Document: **Management Approach for the Debris Areas near the
FTMM-25 Landfill (CW-3A), Charles Wood Area,
Fort Monmouth, NJ**

Subject: Management Approach for the Debris Areas near the FTMM-25 Landfill (CW-3A), Charles Wood Area, Fort Monmouth, NJ

Figure I1 – FTMM-25 Landfill Boundary Refinement and Methane Gas Survey Results

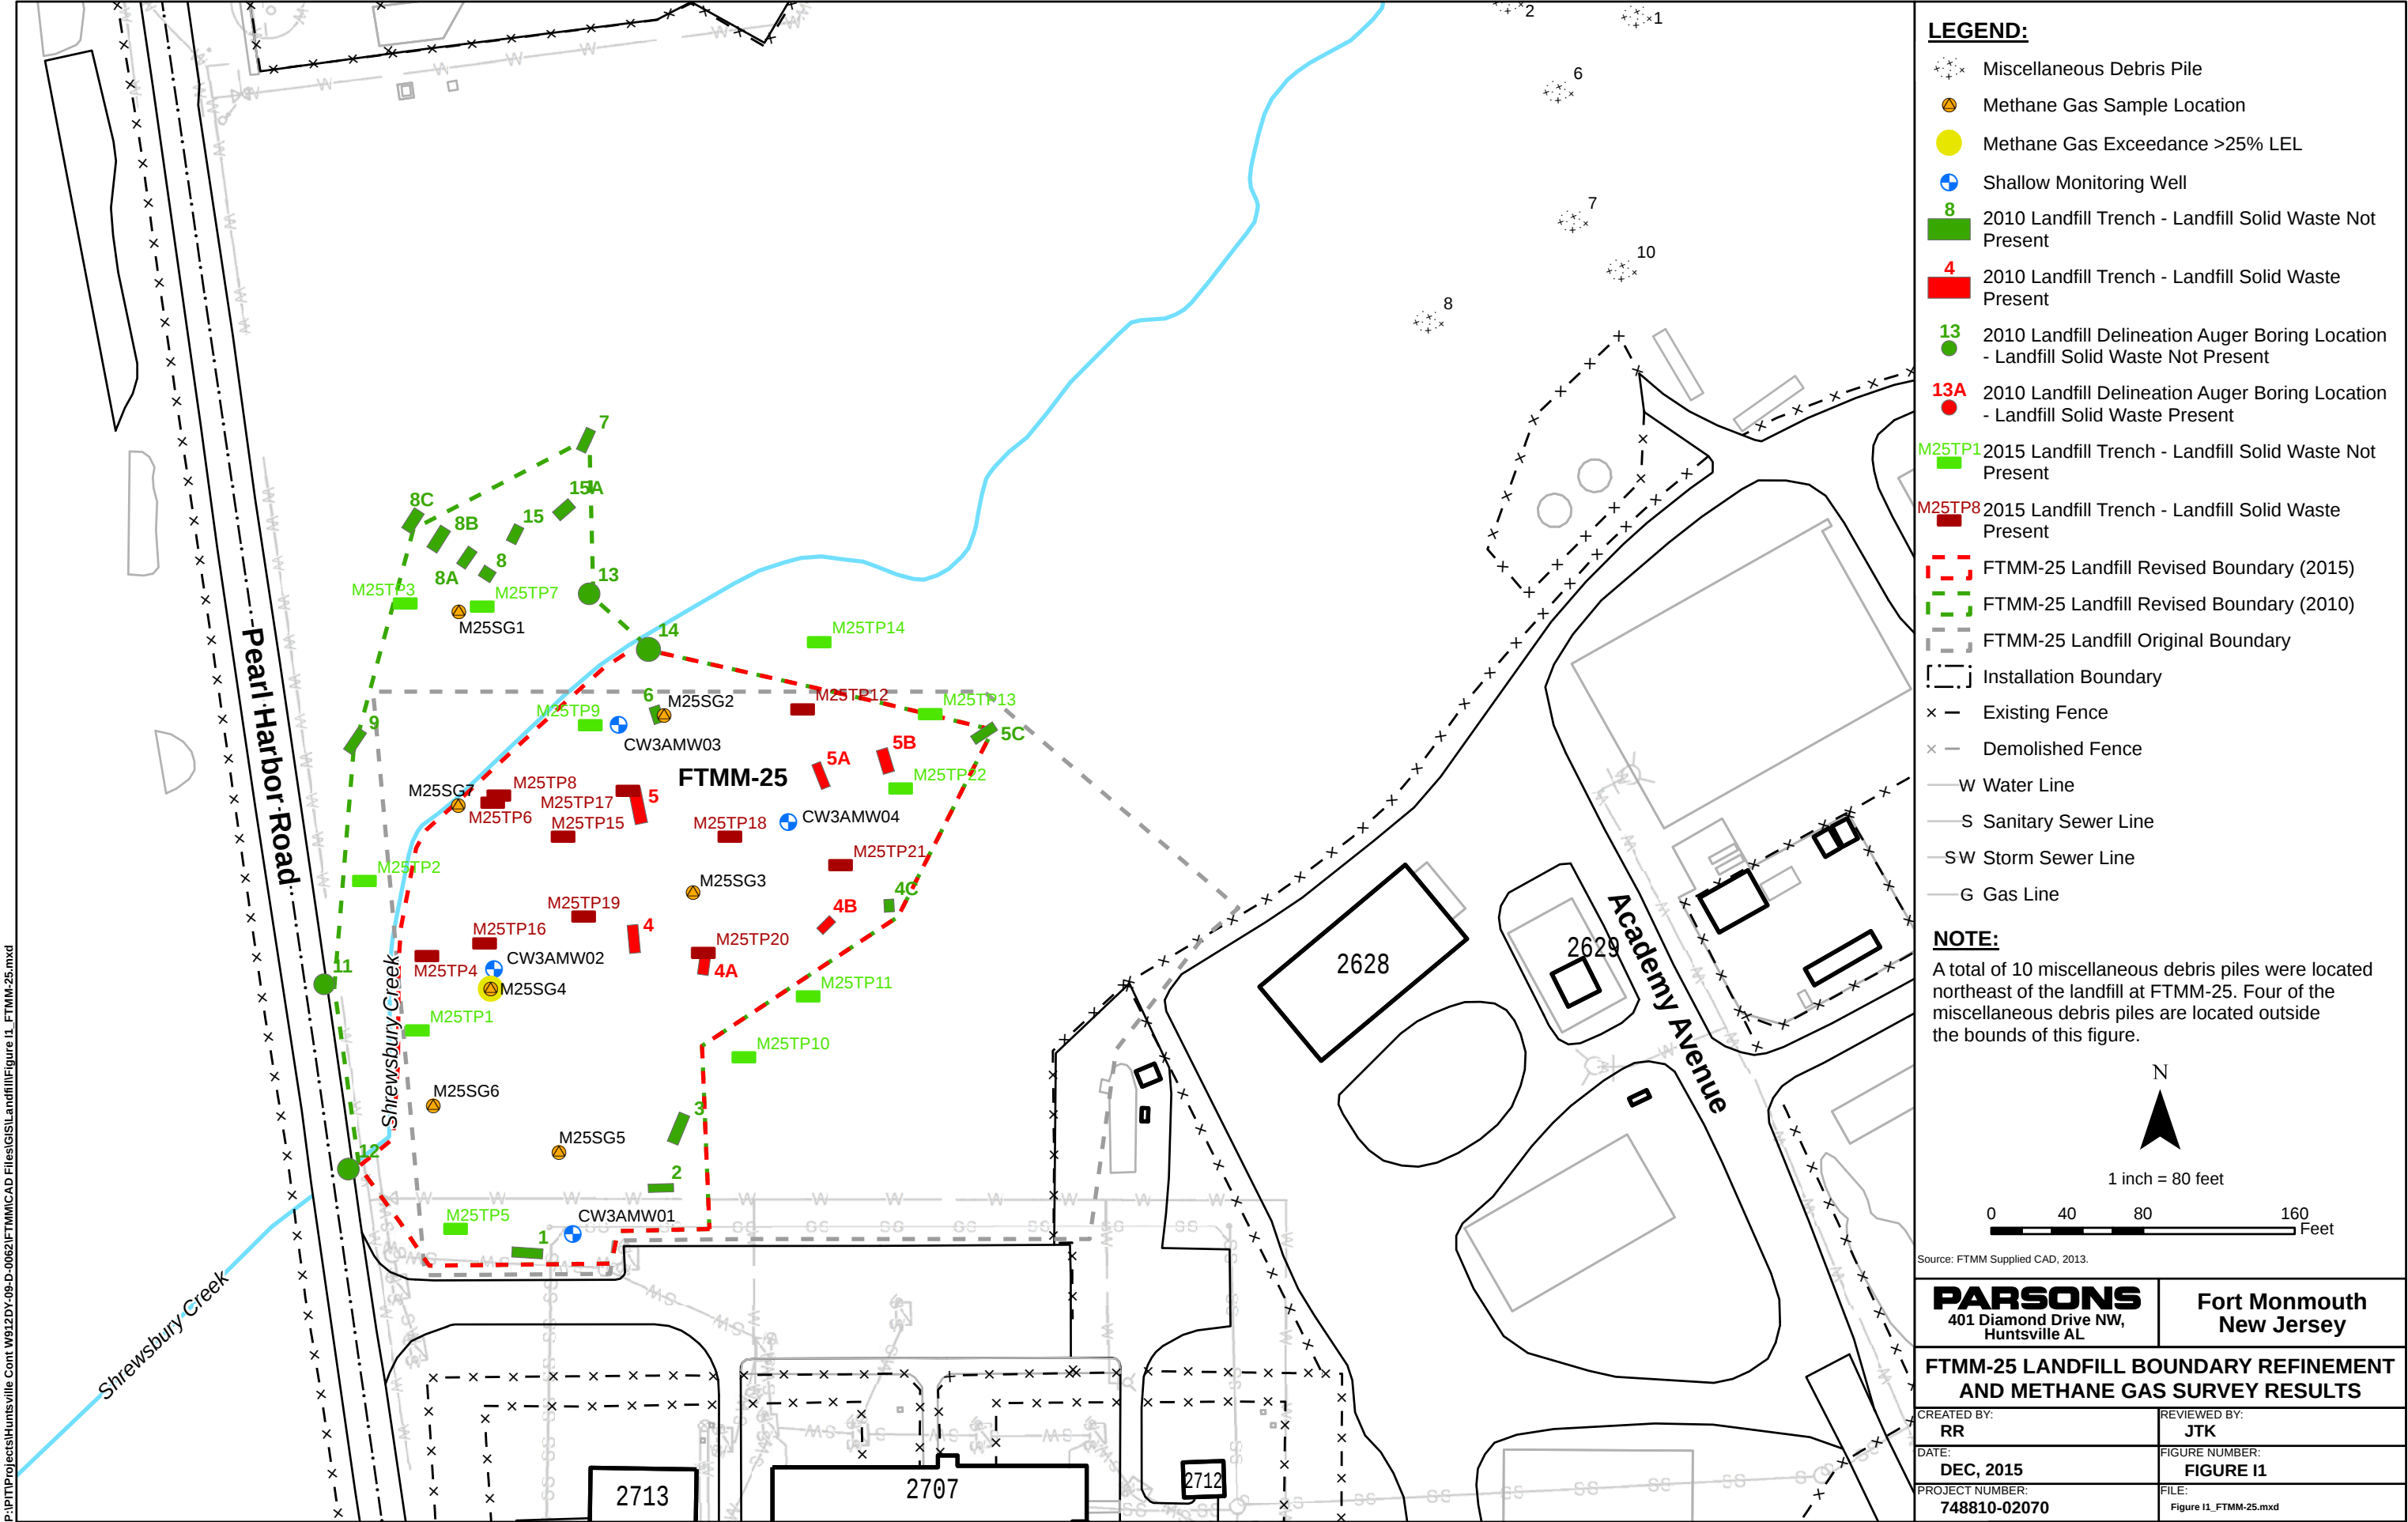
Background: As described in **Reference 1**, ten above-ground debris piles were identified to the northeast of the FTMM-25 landfill (shown on **Attachment B**). These construction debris piles of varying sizes are located approximately 300 feet from the eastern landfill boundary, and are not considered part of the M25 landfill. The delineation of the FTMM-25 landfill has been completed using historical aerial photography and multiple rounds of test trenching, as described in **Reference 1**.

a ground positioning system (GPS) in 2015, and were not contiguous with the FTMM-25 landfill wastes (see **Attachment B**). Therefore, based on the assessment summarized in **Reference 1**, the delineation investigation described in the Army's January 28, 2015 letter (**Attachment A**) has been completed.

Proposed Action: The draft Remedial Investigation report (not submitted yet) for FTMM-25 will propose capping, subject to the New Jersey Department of Environmental Protection concurrence. Included within this capping action, US Army Corps of Engineers proposes to remove the ten construction debris piles and place this material within the footprint of the FTMM-25 landfill area. A minimum of 1-foot depth of the underlying soil will be over-excavated at each debris pile. Field screening for evidence of hazardous materials will be performed during the debris removal activities, including visual observations for suspect materials within the debris piles (such as drums or hazardous material solids), observations of staining of underlying soils, and photoionization detector (PID) readings during excavation activities. As described previously, containment of the FTMM-25 landfill area will be completed by construction of a vegetative soil cover or functional equivalent in accordance with the approved remedy for this site.
